Darden Clean Energy Project (23-OPT-02)

CEC Data Request Response Set #4

IP Darden I, LLC and Affiliates

Figure 5.13-3a Groundwater Elevation Contours – Current Conditions, Upper Aquifer

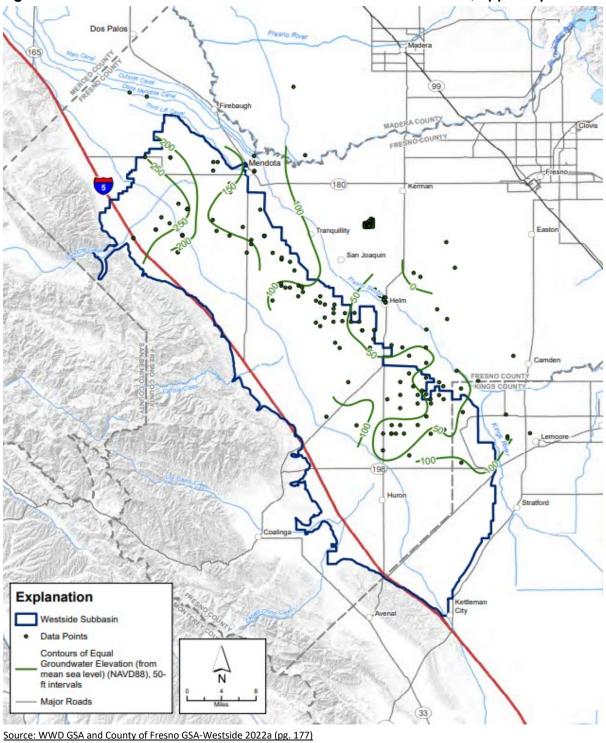
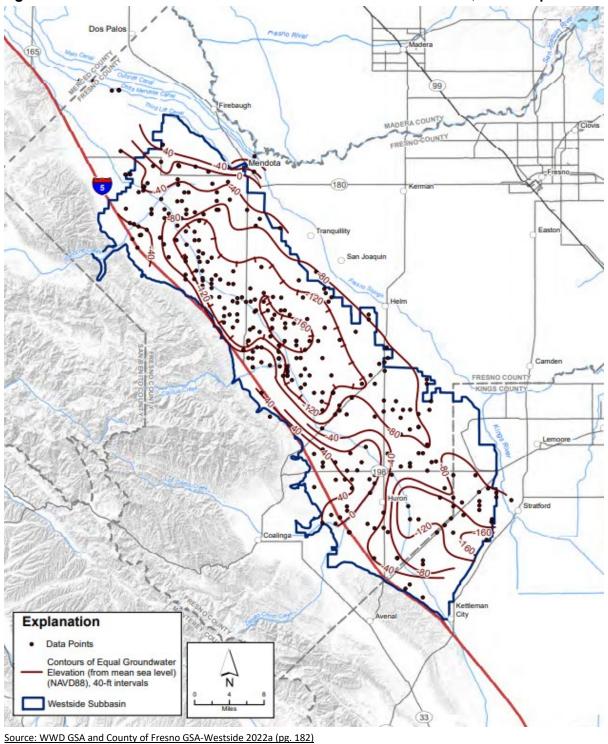
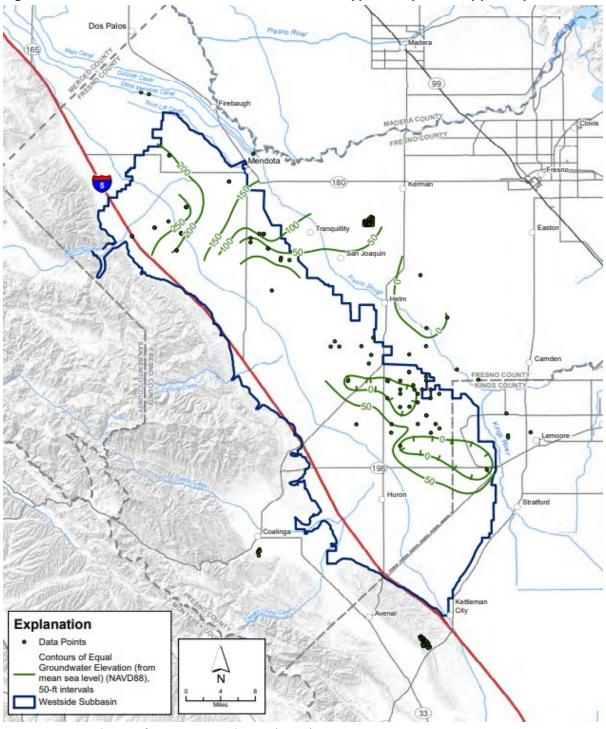
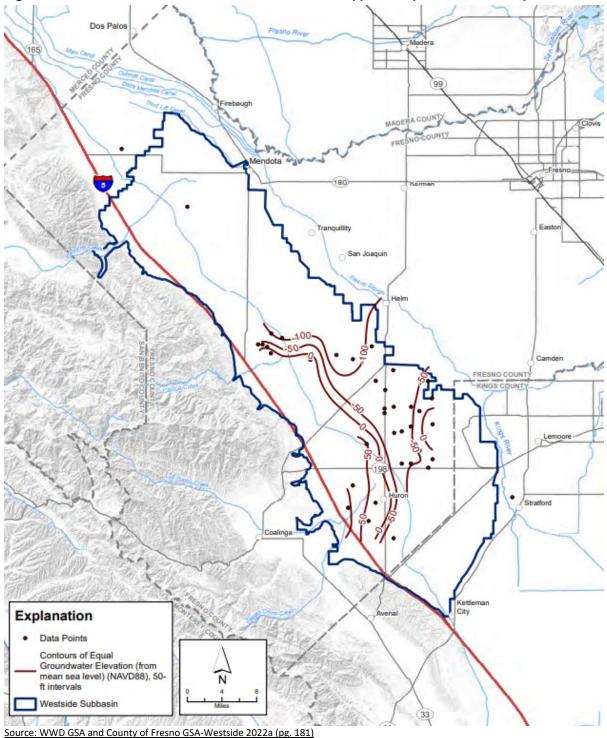
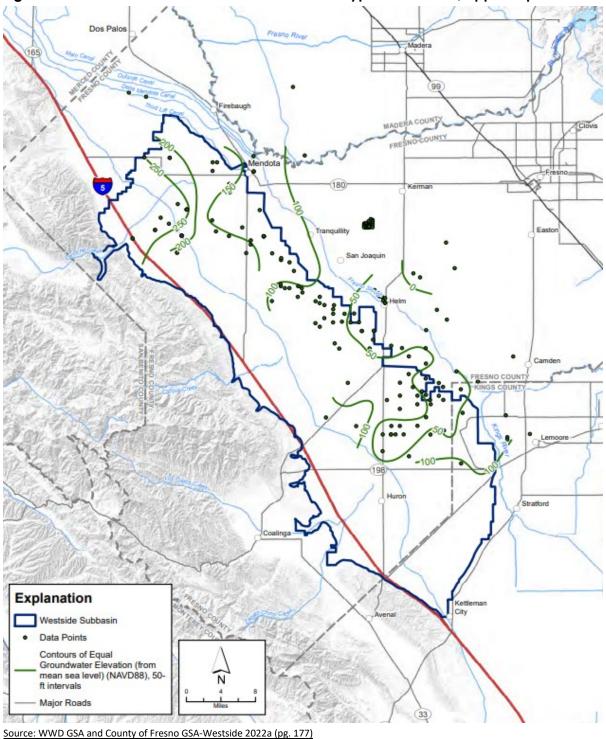
DR WATER-4: Please re-evaluate Figure 5.13-3 and provide a detailed explanation of modifications made and any assumptions, methodologies, and computational methods used.

Response: The original Figure 5.13-3, *Depth to Groundwater*, incorrectly showed ground surface elevation, not depth to groundwater. That figure should be replaced with the graphics presented below, identified as Figures 5.13-3a through 5.13-3f, which were sourced from the Westside Subbasin GSP (WWD GSA and County of Fresno GSA-Westside 2022a) and reflect three different time periods representing current conditions, dry years, and wet years, as follows:

Figures 5.13-9a Groundwater Well Locations Overview

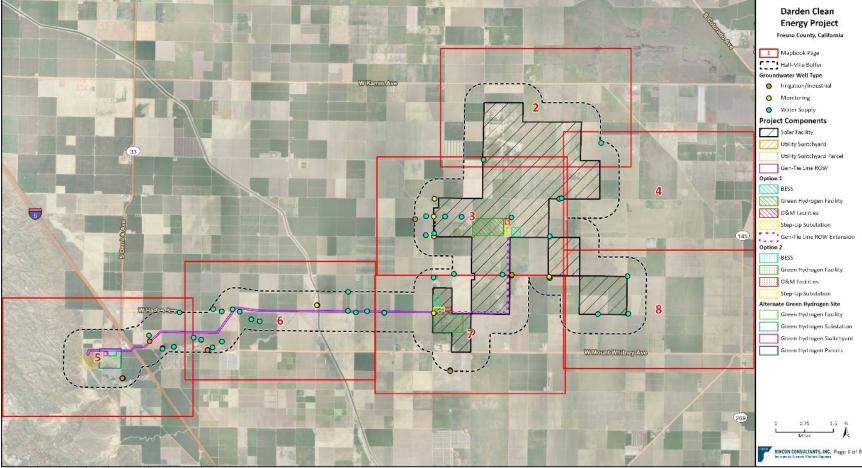
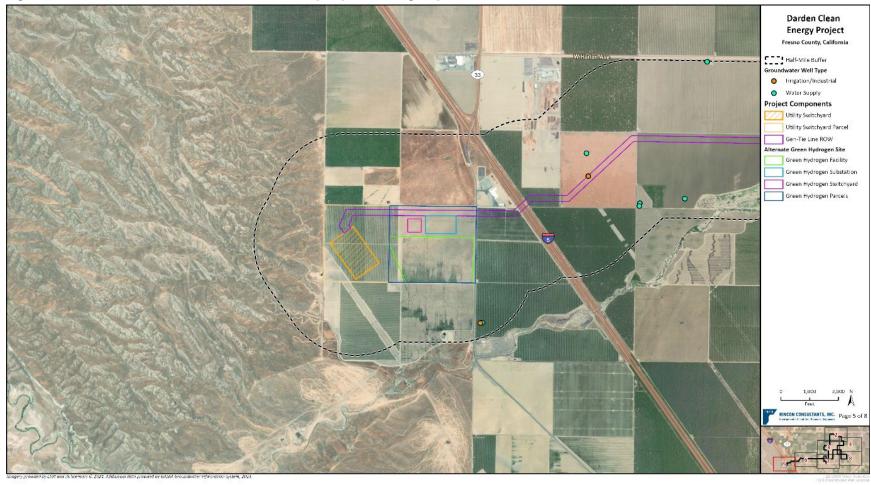
DR WATER-9: Please revise the figures to indicate the well types (e.g., irrigation, domestic, etc.).

Response: Figures 5.13-9a through 5.13-9h have been revised to identify the types of wells present within 0.5 mile of the Project site; the updated figures are provided below.
